HISTORIC AND DESIGN REVIEW COMMISSION

December 07, 2022

HDRC CASE NO: 2022-562
ADDRESS: 603 CEDAR ST
LEGAL DESCRIPTION: NCB 2913 BLK 2 LOT 12 AT 603 CEDAR
ZONING: RM-4, H
CITY COUNCIL DIST.: 1
DISTRICT: King William Historic District
APPLICANT: Dan Gonzalez/Texas Outdoor Design Build
OWNER: Michael Bryant/BRYANT MICHAEL A & Julie Engel
TYPE OF WORK: Driveway apron modifications
APPLICATION RECEIVED: November 09, 2022
60-DAY REVIEW: Not applicable due to City Council Emergency Orders
CASE MANAGER: Claudia Espinosa

The applicant is requesting a Certificate of Appropriateness for approval to expand the existing driveway approach to be twenty (20) feet wide at the curb cut.

1 SITE PLAN

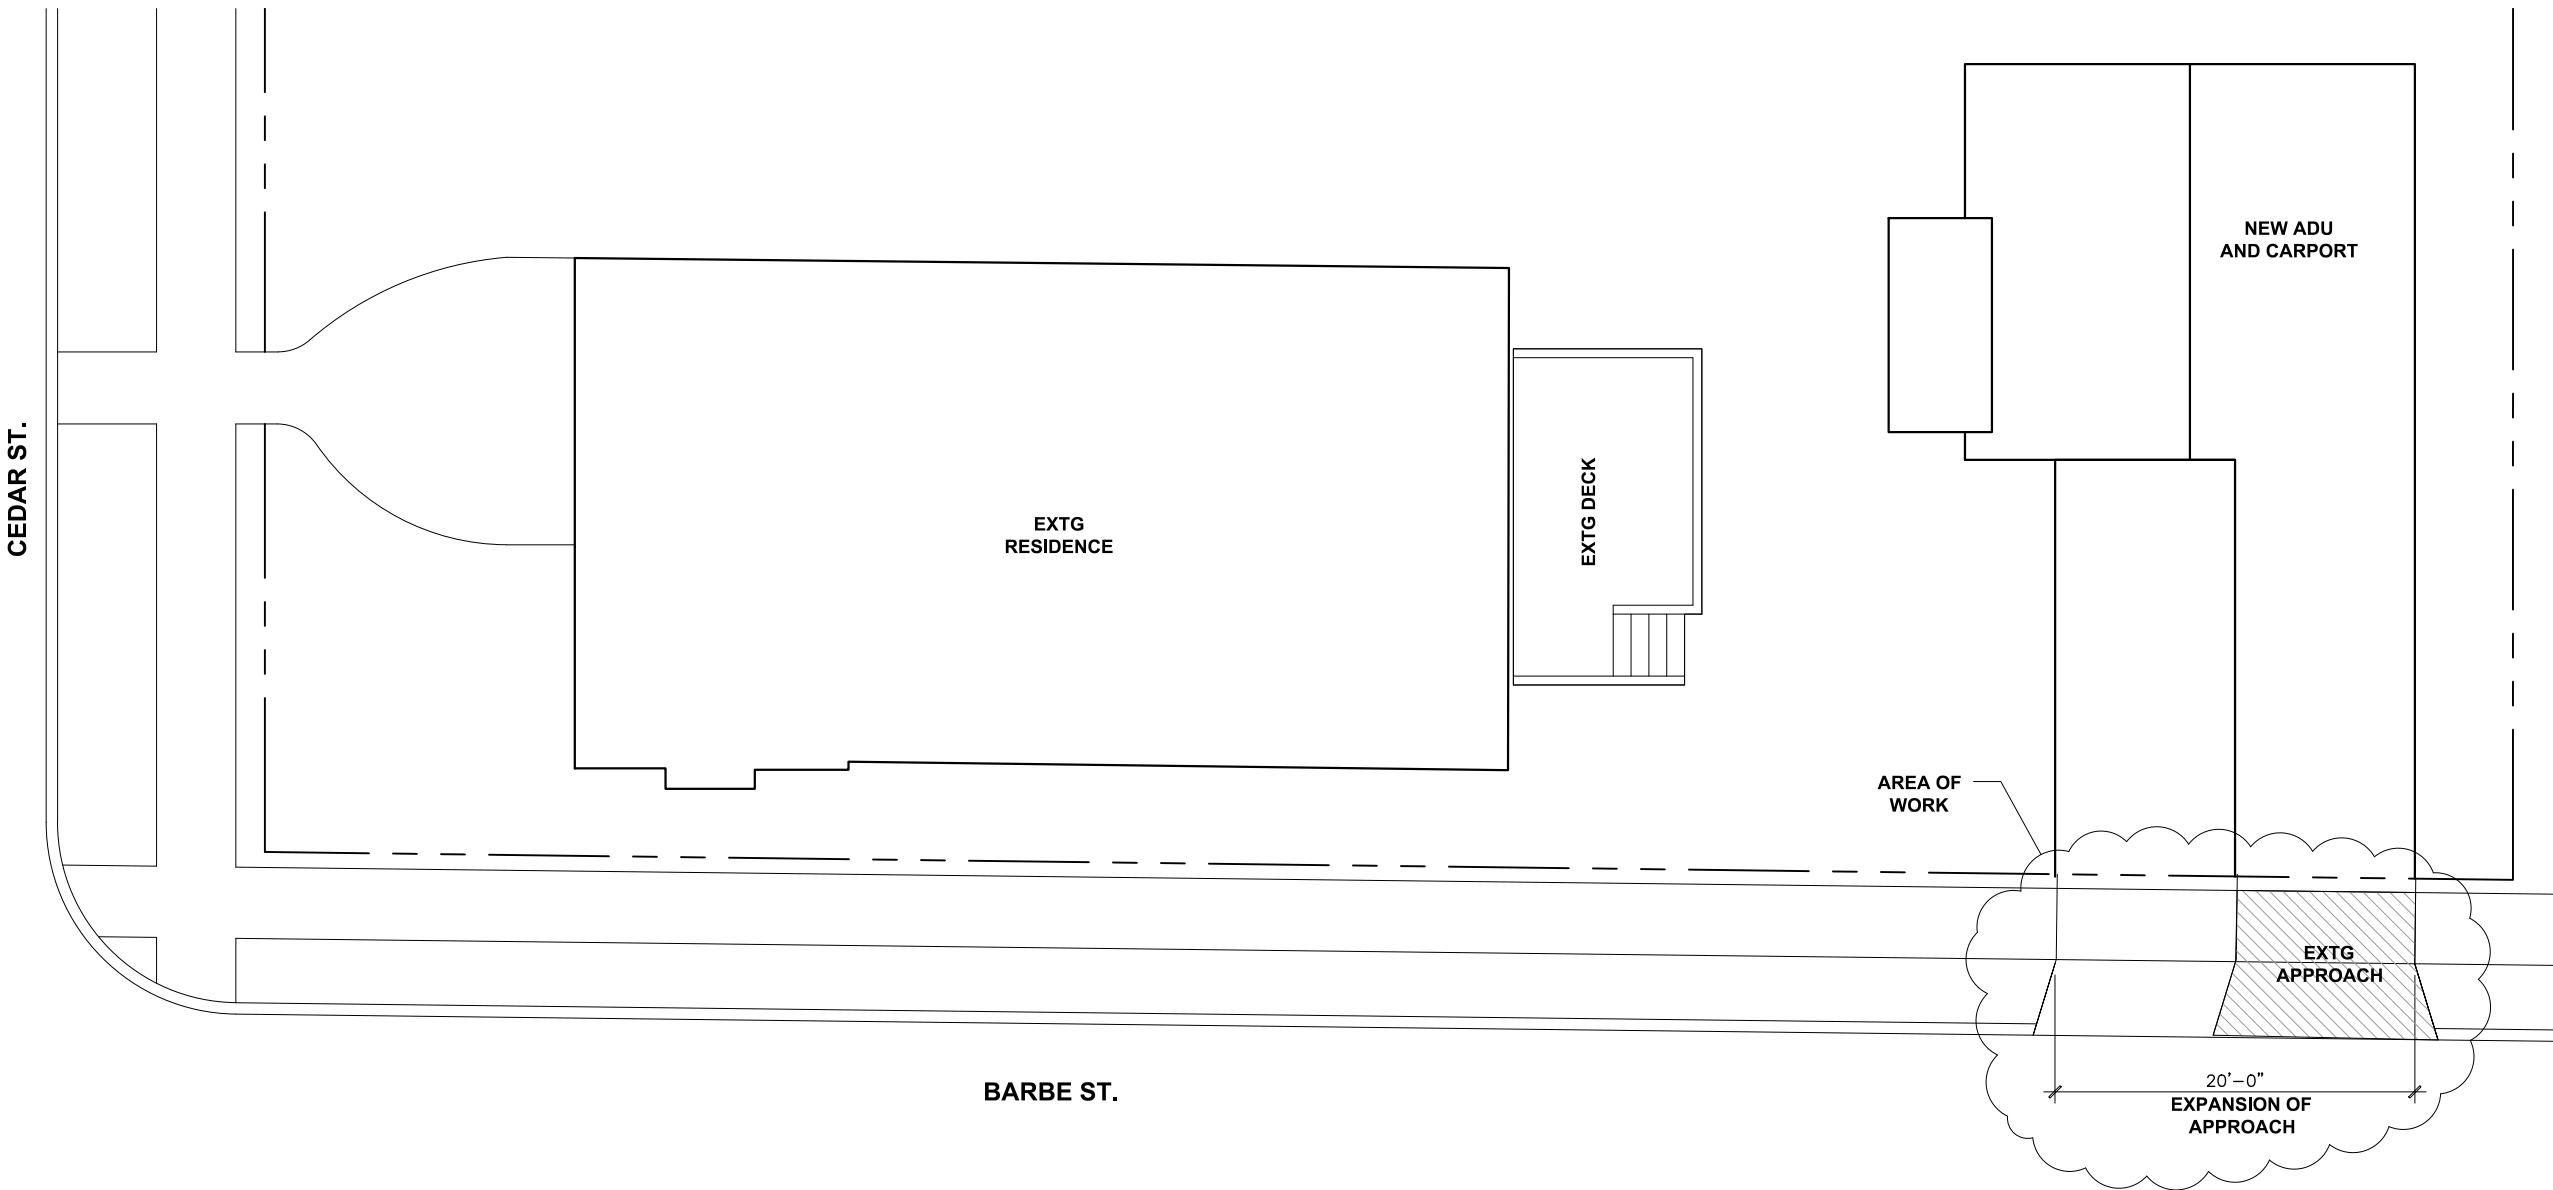
b. The applicant has proposed to widen the existing concrete driveway apron to twenty (20) feet to accommodate a double-width curb cut, apron and driveway approach. According to Guideline 5.B.ii for Site Elements, the replacement of historic driveways should maintain the width and configuration of original curb cuts and applicants should avoid introducing new curb cuts where not historically found. This request to double the width of the existing curb cut, which features a profile prominently found within the King William Historic District is not consistent with the guidelines.

Staff does not recommend approval to expand the existing driveway approach to twenty (20) feet based on finding b.
